January 20, 2022  
File No. 05.00043654.60

Re: Site Remediation File No. SR-26-0934A/Formerly RIDEM Case No. 95-022  
Former Tidewater Facility  
200 Taft Street  
Pawtucket, Rhode Island

### CRMC ASSENT MODIFICATION

**ALTERNATIVE REVEMENT LAYOUT PLAN**

DATE: JANUARY 2022	PROJECT NO. 43654.40	DRAWN BY: SAB	SCALE: AS SHOWN
		REVISION NO.	DRAWING <b>S-65A</b> SHEET NO. 25 OF 74

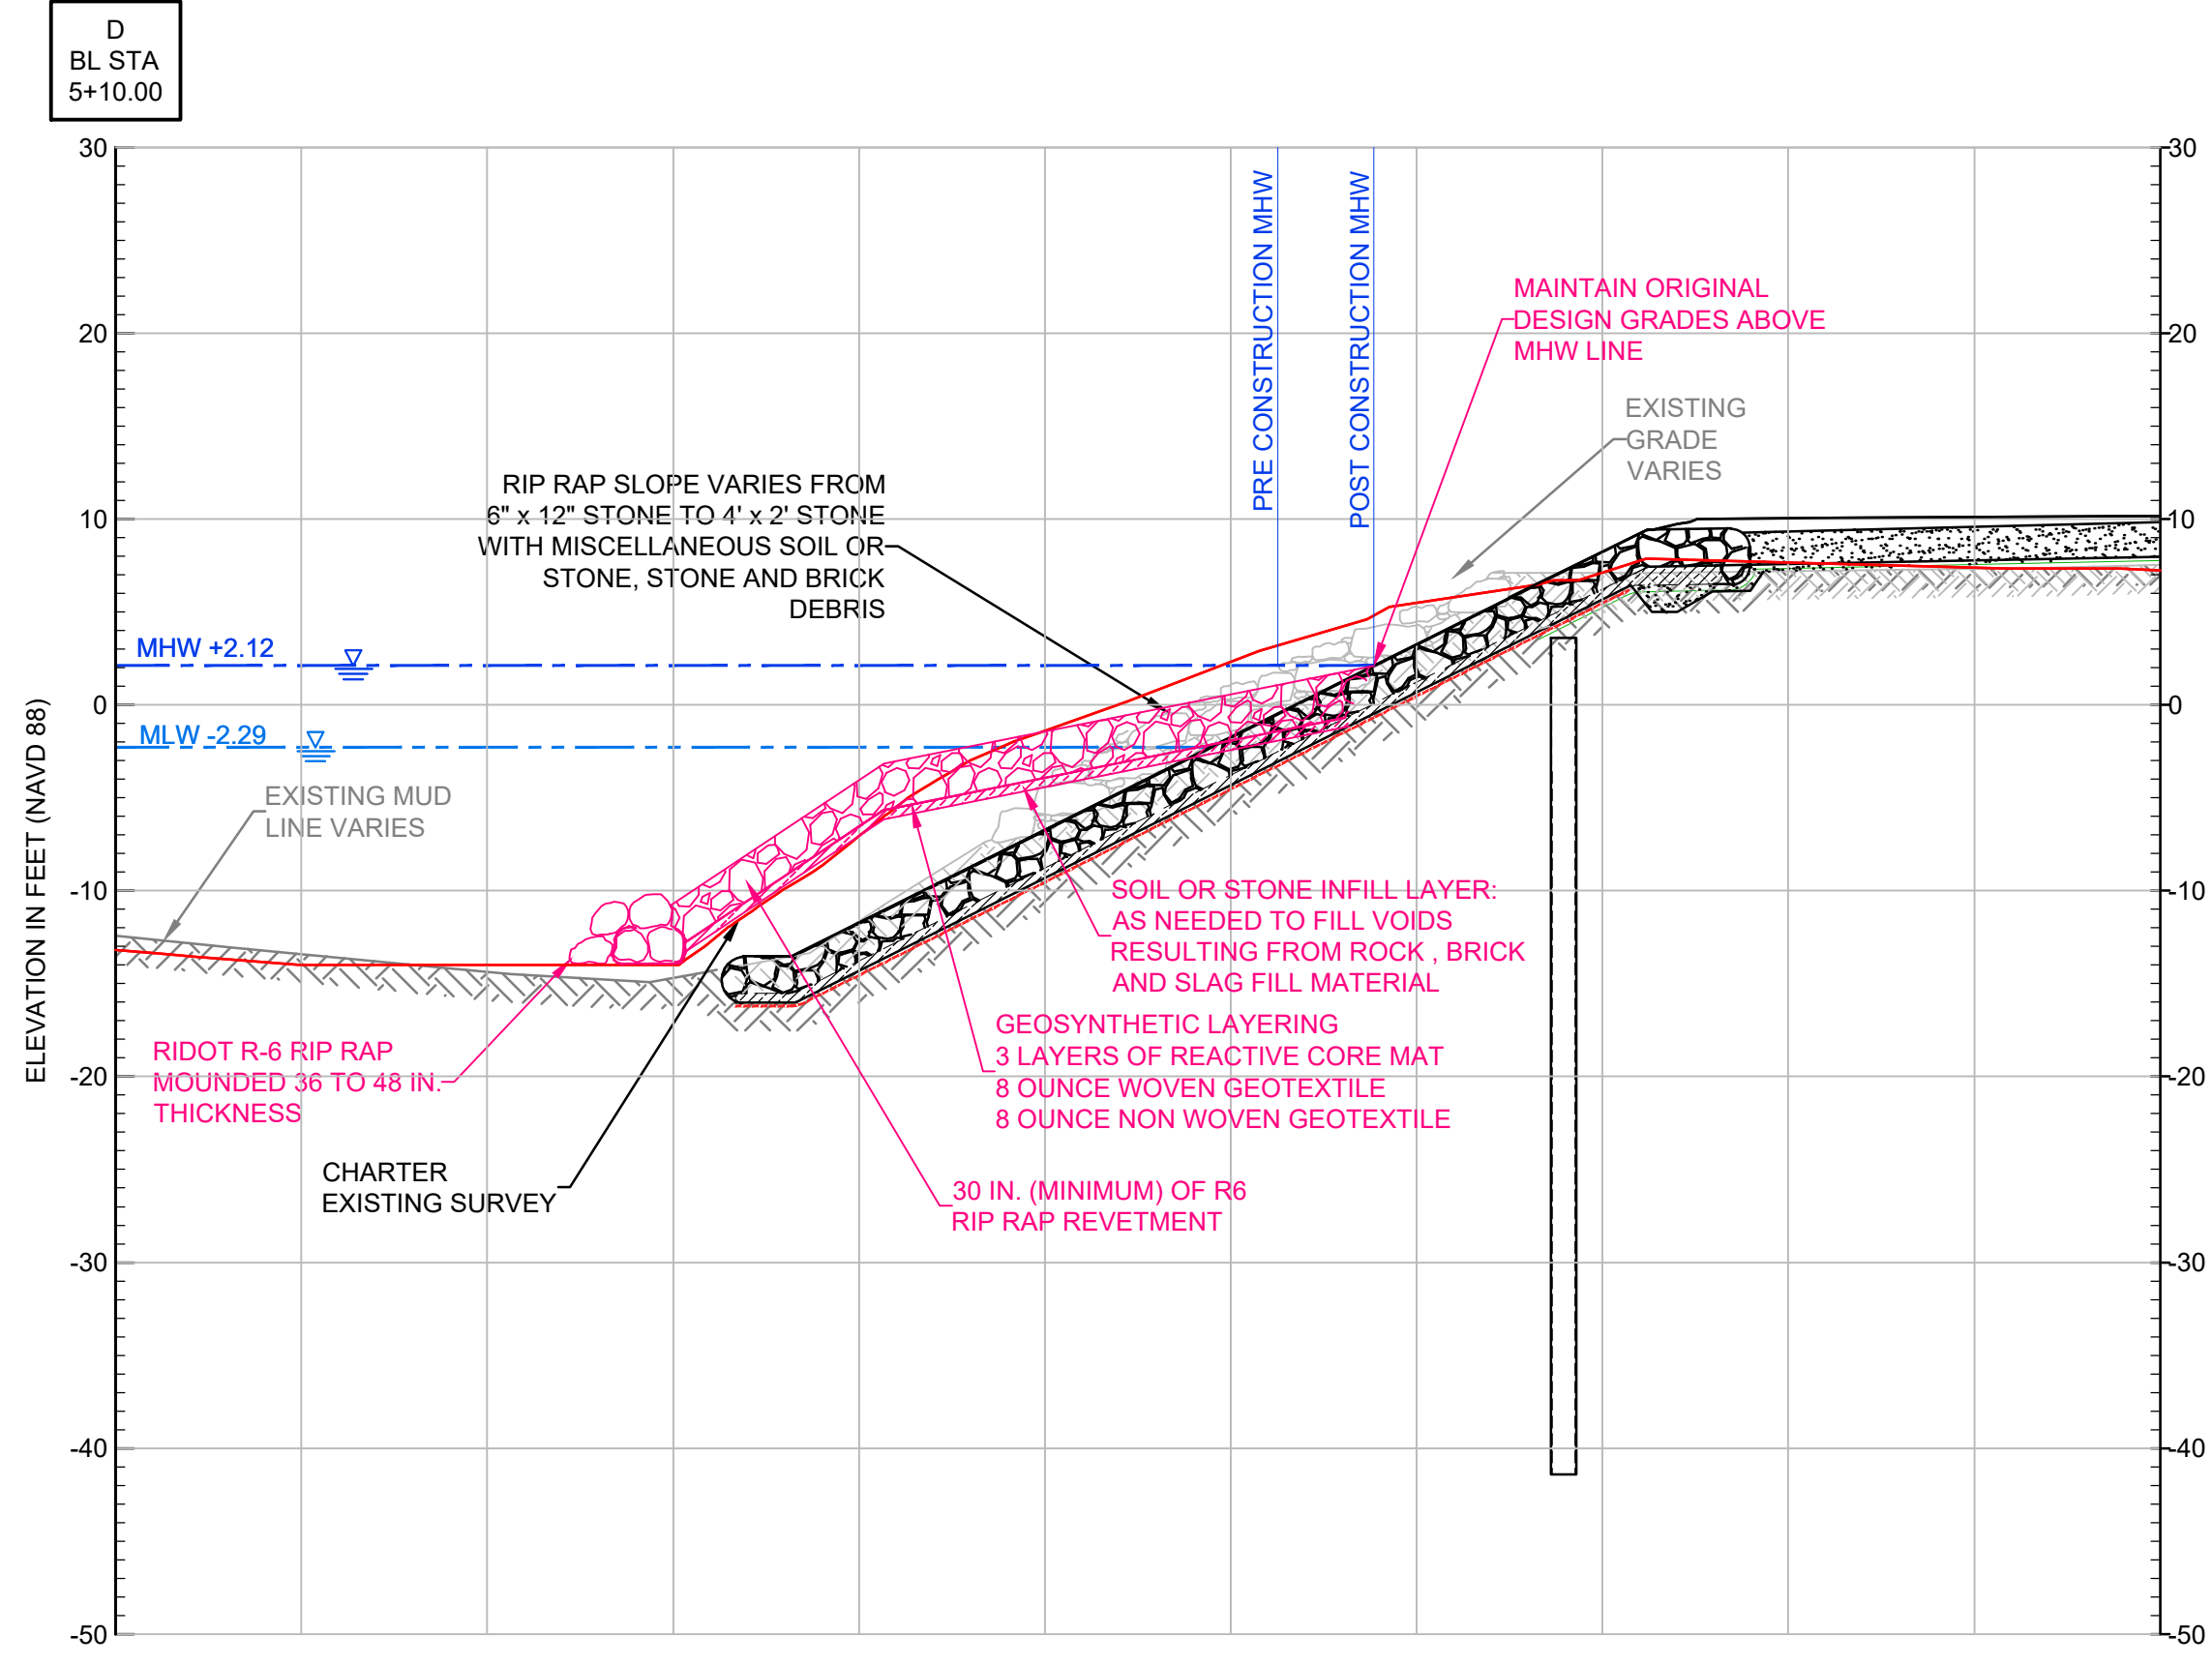
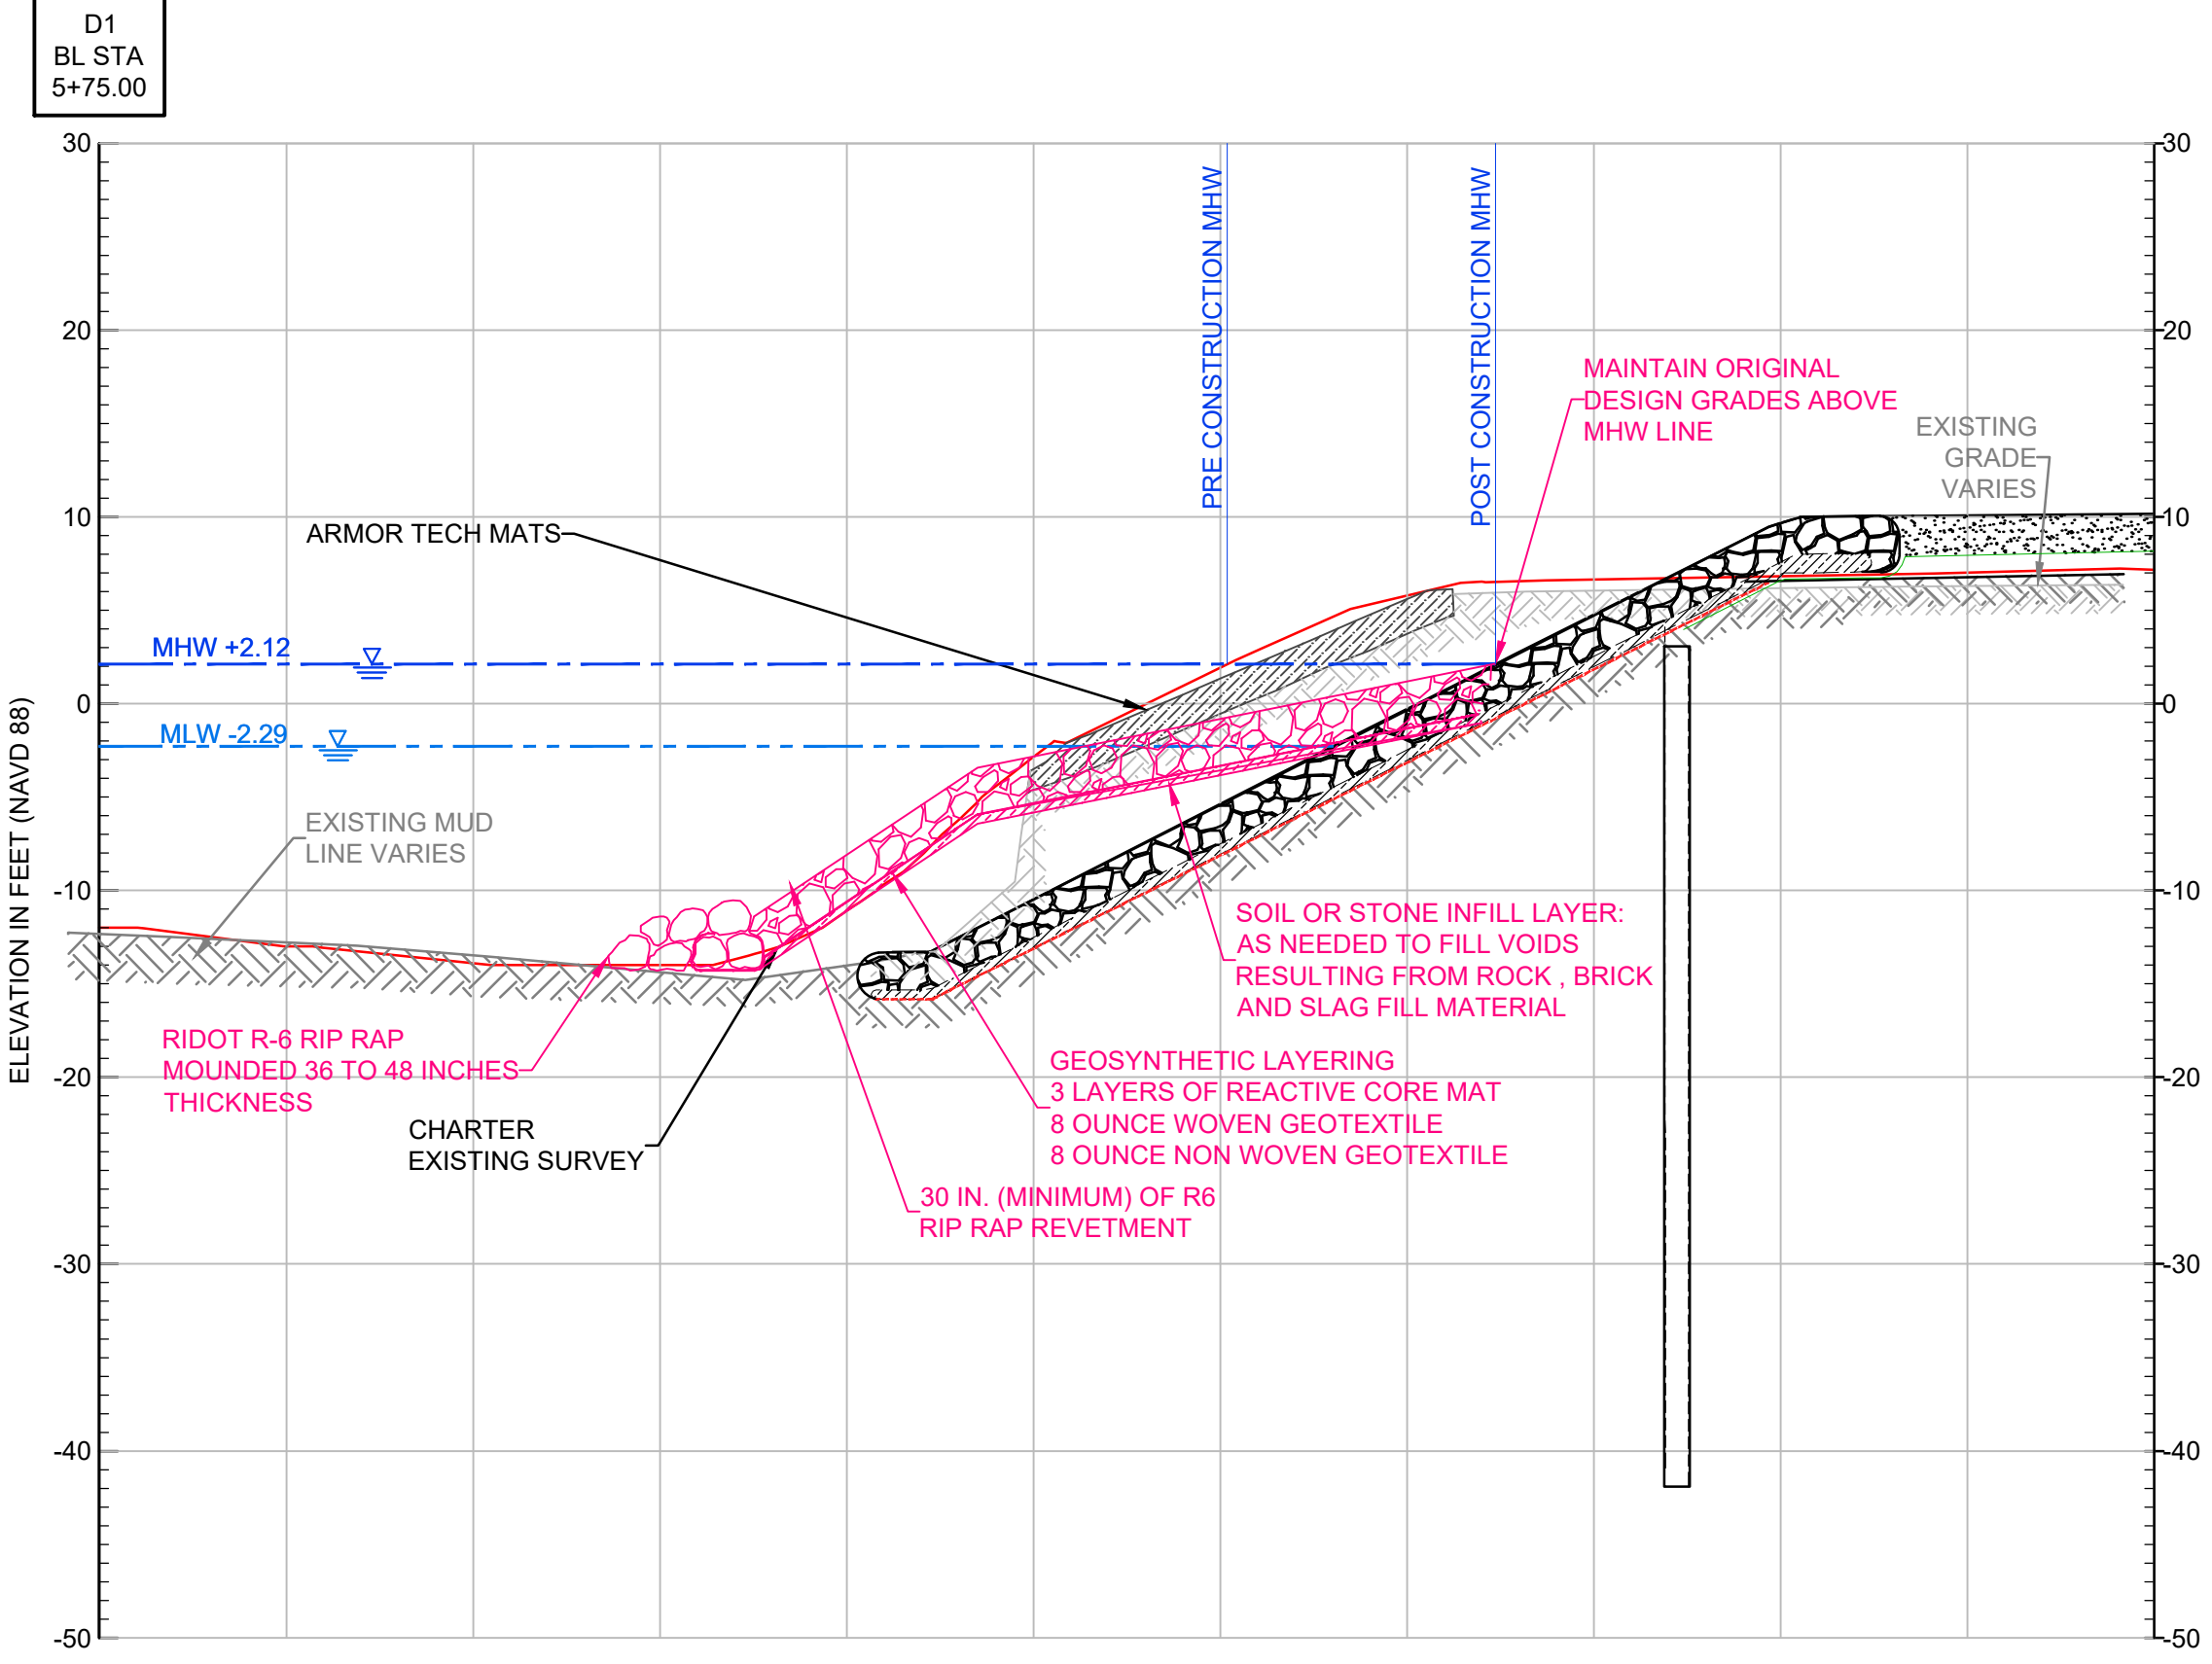
2. The approved site plans shall be those titled "Former Tidewater Facility, Pawtucket, Rhode Island, Contract Document Phase 4 and 4, Alternative Revetment Layout Plan...", sheets 1 and 2 (Drawing S-62A and S-65A) dated January 2022, by GZA Inc.. Except as stipulated or modified herein, all details and specifications thereon shall be strictly adhered to. Any and all changes require written approval from this office.

This work is located in the Seekonk River located at 200 Taft Street in Pawtucket, Rhode Island. The revised work is shown on the enclosed plans titled "FORMER TIDEWATER FACILITY PAWTUCKET RHODE ISLAND CONTRACT DOCUMENTS PHASE 4 & 5 ALTERNATIVE REVETMENT LAYOUT PLAN" on two sheets dated "JANUARY 2022".
